STEAMBOAT GONDOLA RELOCATION

STEAMBOAT SPRINGS, CO

No.	Description	Date
1	Addendum #1	3-12-2021
2	Addendum #2	3-28-2021
3	ASI #1	4-19-2021
4	ASI #2	6-7-2021

Project Phase CONSTRUCTION DOCUMENTS
Sheet Title CONCRETE SLAB SLOPE CLARIFICATION
Sheet Number SK-01

**STEAMBOAT GONDOLA
RELOCATION**
STEAMBOAT SPRINGS, CO

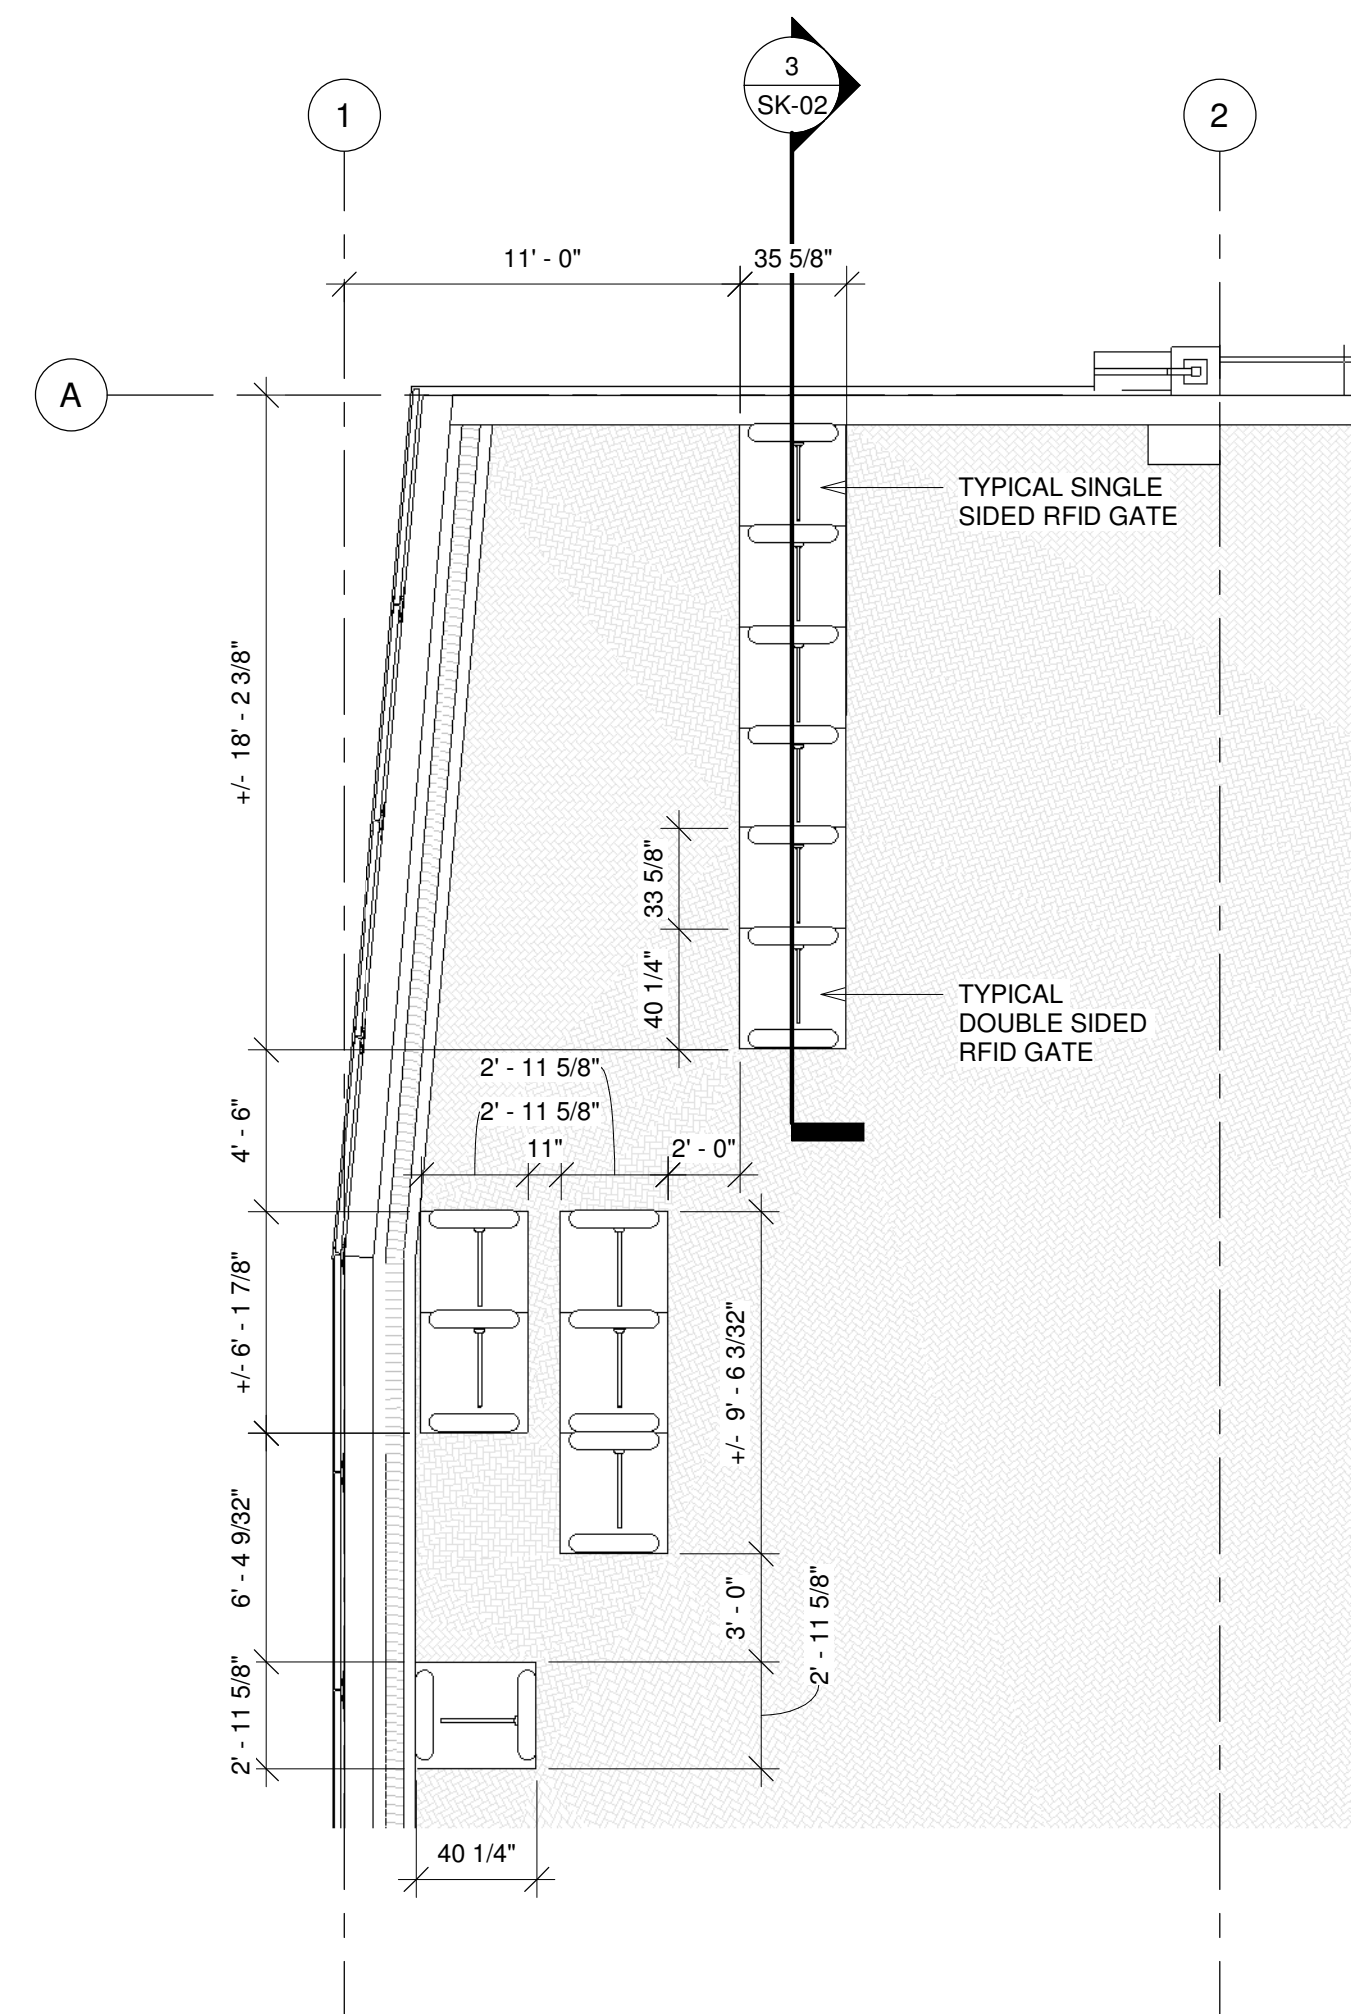
4. PLATFORM PAVERS TO SLOPE AT 2% MAX. RIDF GATES TO BOLT TO CONCRETE SLABS BELOW. ALL GATES ATTACH TO EACH OTHER AND CAN SLOPE MAXIMUM AS A UNIT. SHIM BELONGS TO RIDF GATE PALLETS AND/OR ADJUSTABLE PAVERS MINIMUM. THERE IS NO STEP BETWEEN THE TWO. GUESTS SHOULD WALK ACROSS A FLUSH SURFACE FROM PAVEMENT TO RIDF GATE PALLET AND BACK TO PAVEMENT.
